SUBJECT: ISSUANCE OF AMENDMENT NO. 9 TO FACILITY OPERATING LICENSE NO.
NPF-74 FOR THE PALO VERDE NUCLEAR GENERATING STATION, UNIT 3
(TAC NO. 67865)

PALO VERDE NUCLEAR GENERATING STATION, UNIT NO. 3

AMENDMENT TO FACILITY OPERATING LICENSE

Amendment No. 9
License No. NPF-74

FIGURE 3.1-1
ALLOWABLE MTC MODES 1 AND 2
PALO VERDE UNIT 3 CYCLE 1

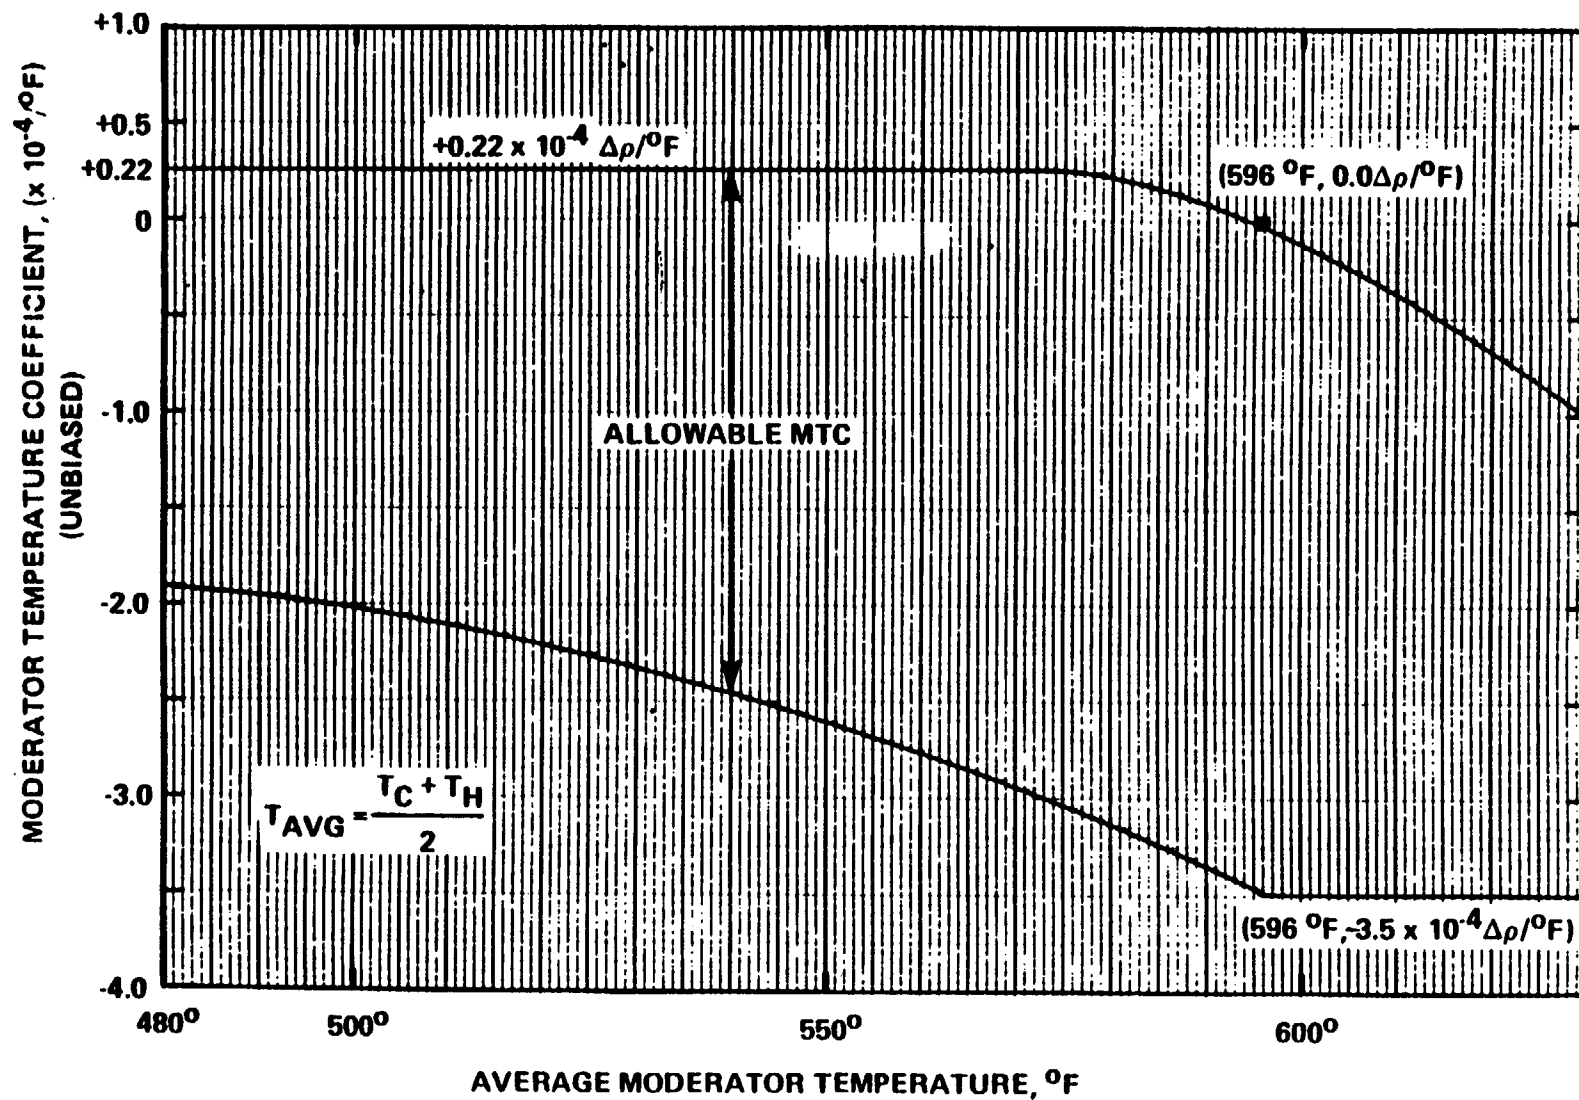
The Amendment revises the Technical Specifications for Palo Verde Unit 3, as follows. Technical Specification 3/4.1.1.3 provides limits on the Moderator Temperature Coefficient (MTC). The Amendment revises Figure 3.1-1 to increase the negative MTC limit from -30 pcm/°F to -35 pcm/°F.

The Amendment revises the Technical Specifications for Palo Verde Unit 3, as follows. Technical Specification 3/4.1.1.3 provides limits on the Moderator Temperature Coefficient (MTC). The Amendment revises Figure 3.1-1 to increase the negative MTC limit from -30 pcm/°F to -35 pcm/°F.

The TS limit on MTC was determined from the CE System 80 steam line break analysis. In the analysis, an assumed moderator reactivity versus coolant temperature function was applied using the most negative (including uncertainties) technical specification moderator temperature coefficient of $-35 \text{ pcm}/^{\circ}\text{F}$ at nominal full power conditions, $T_{\text{avg}} = 594^{\circ}\text{F}$.

The current MTC limit of $-30 \text{ pcm}/^{\circ}\text{F}$ in the Unit 3 TS was required to compensate for the as-built safety injection drain line configuration. Subsequently the drain lines were reconfigured so that the MTC limit of $-35 \text{ pcm}/^{\circ}\text{F}$ that was assumed in the safety analyses would be valid.

Based on the above, the staff concludes that the proposed change to Specification 3/4.1.1.3 is acceptable.
